MONITORING YEAR 3 ANNUAL REPORT

AGONY ACRES MITIGATION SITE

RE: Draft Monitoring Year 3 Report for Agony Acres Mitigation Site (95716)
Cape Fear River Basin (03030002)
Guilford County, North Carolina
Contract No. 004949

We have reviewed the comments on the Monitoring Year 3 Report for the above referenced project dated December 22, 2017 and have revised the report based on these comments. The revised documents are submitted with this letter. Below are responses to each of your comments. For your convenience, the comments are reprinted with our response in italics.

Figure 3.3 Integrated Current Condition Plan View
 (Sheet 3 of 3)
 Agony Acres Mitigation Site
 DMS Project No. 95716
 Monitoring Year 3 - 2017
 Guilford County, NC

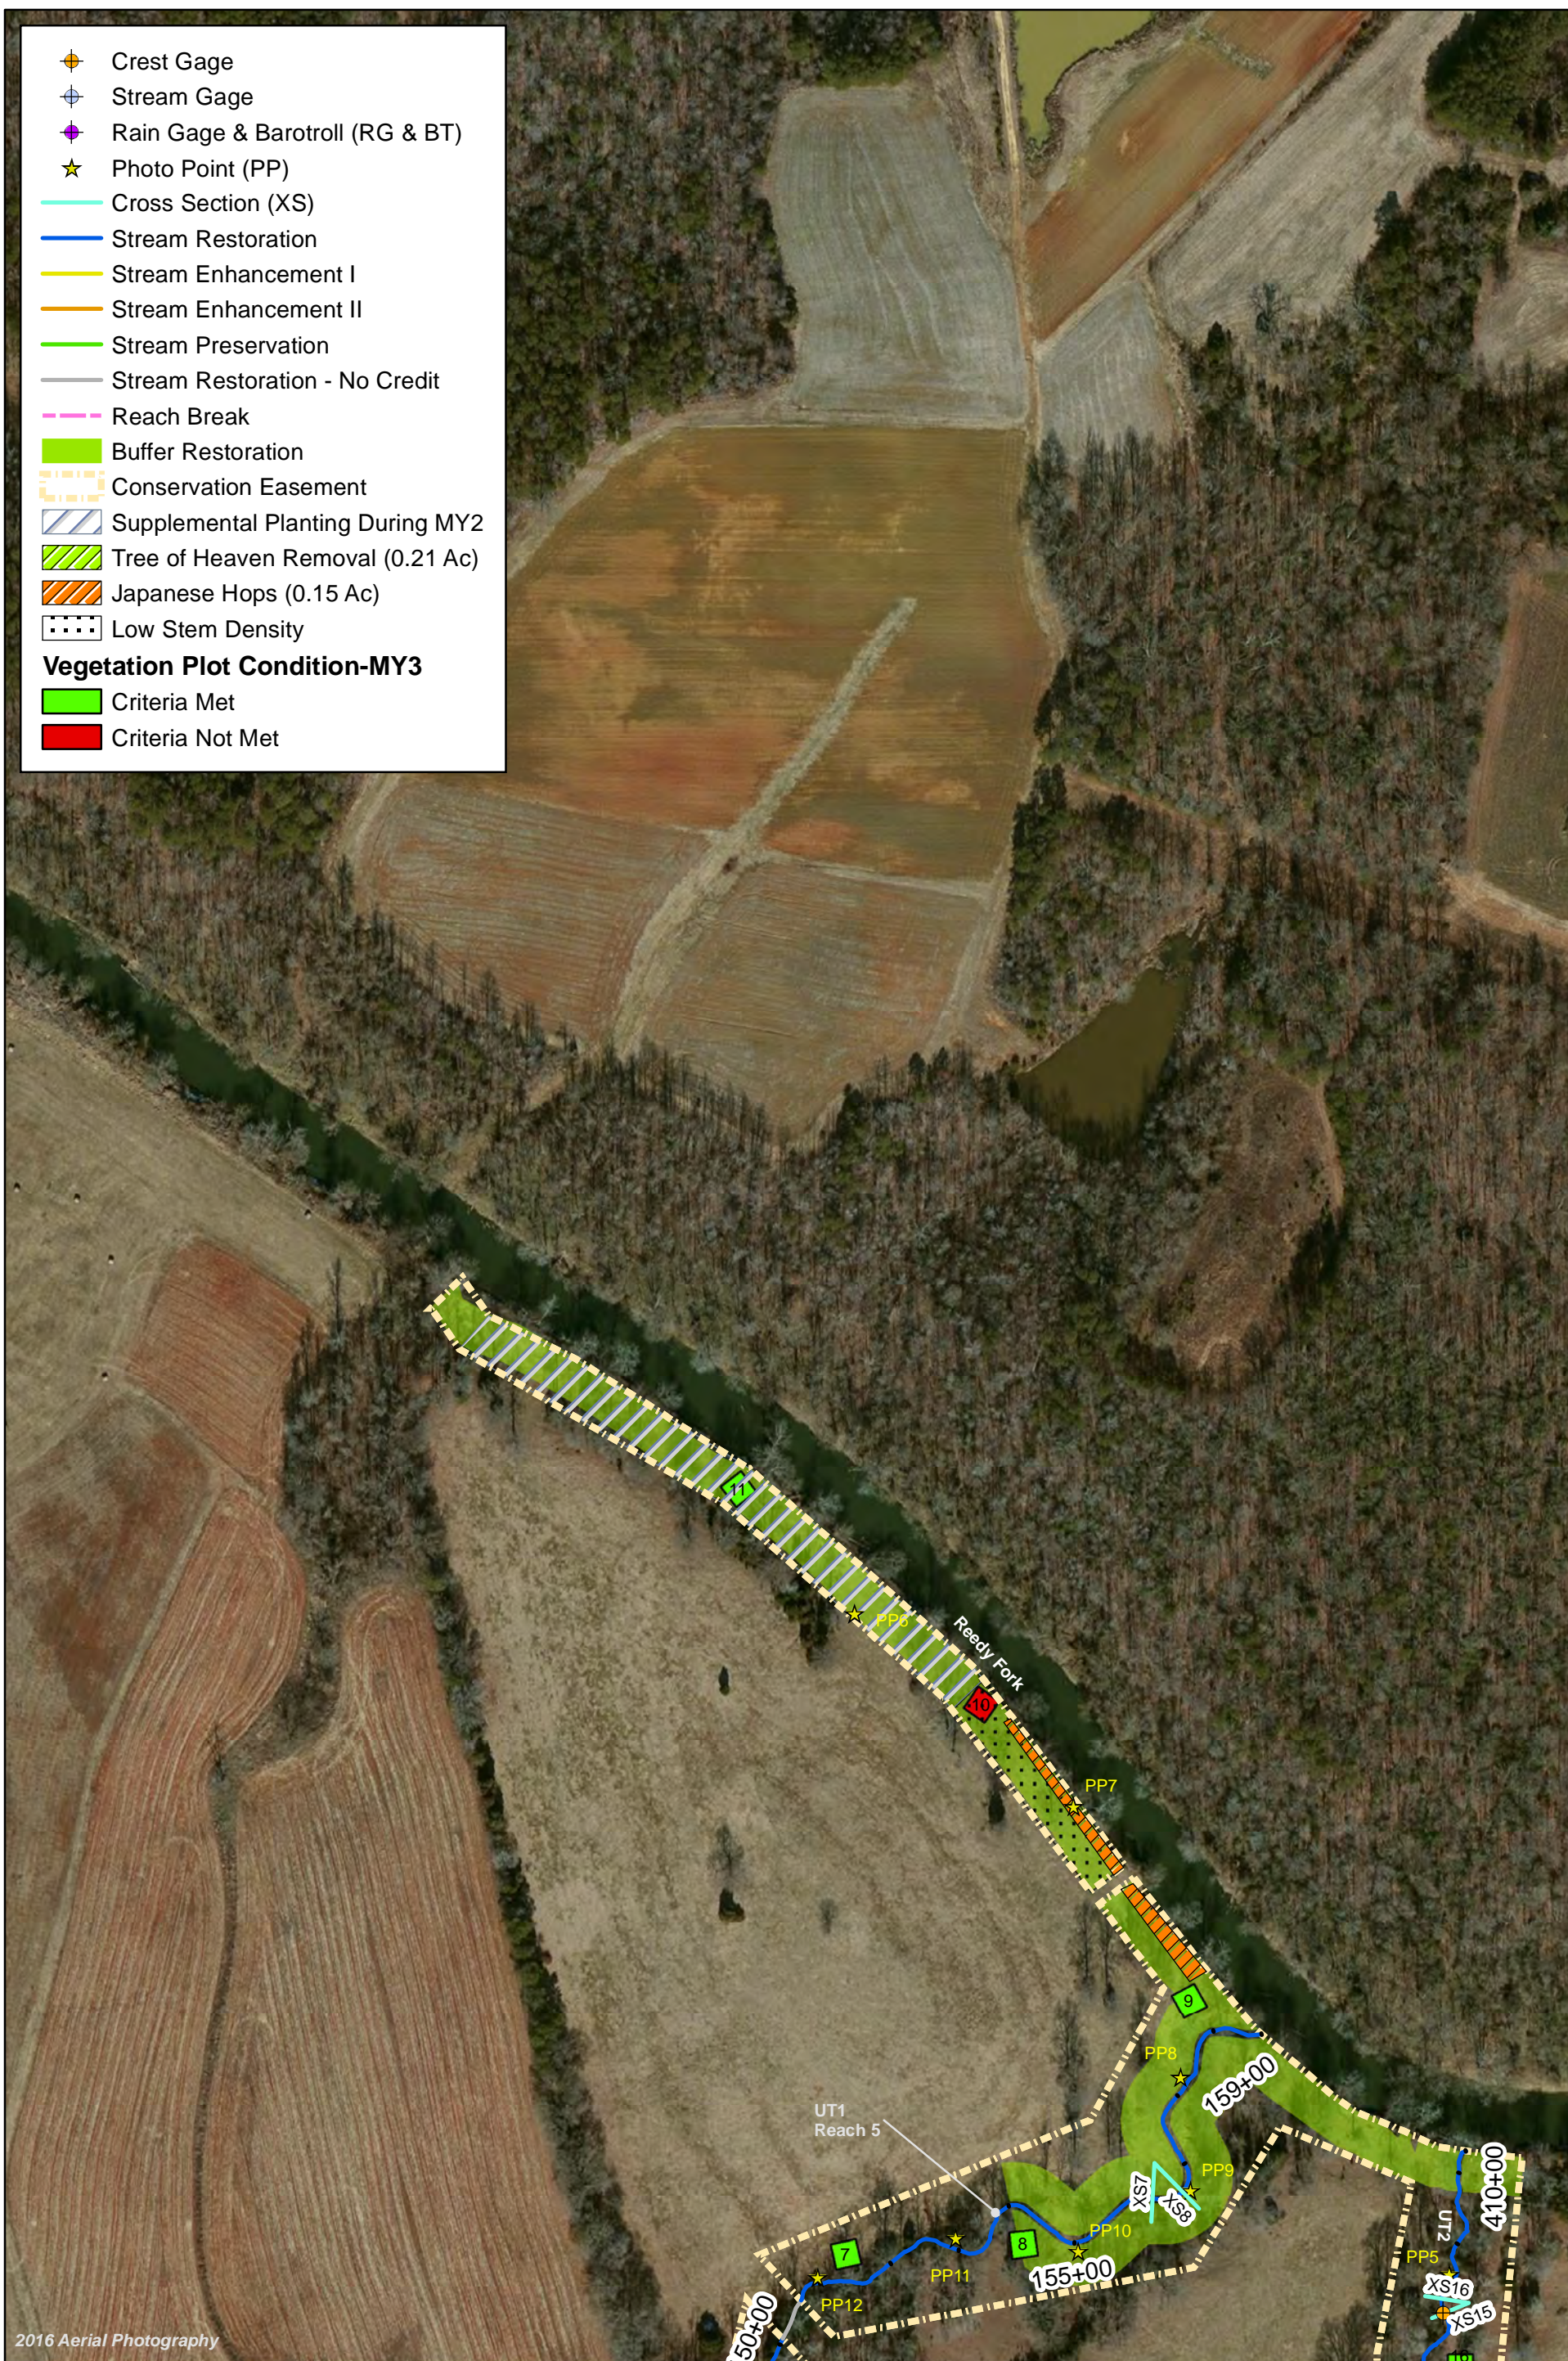
- 6) Appendix 2, Table 6: Given the low stem density in veg. plot 10, DMS expected to see this reflected in Table 6, especially since Wildlands did show it for the low stem density in the vicinity of plot 10 in MY 2. Please explain or update Table 6.

The CCPV Map has been updated to show an area of low stem density around vegetation plot 10, and the area has been added to Table 6.
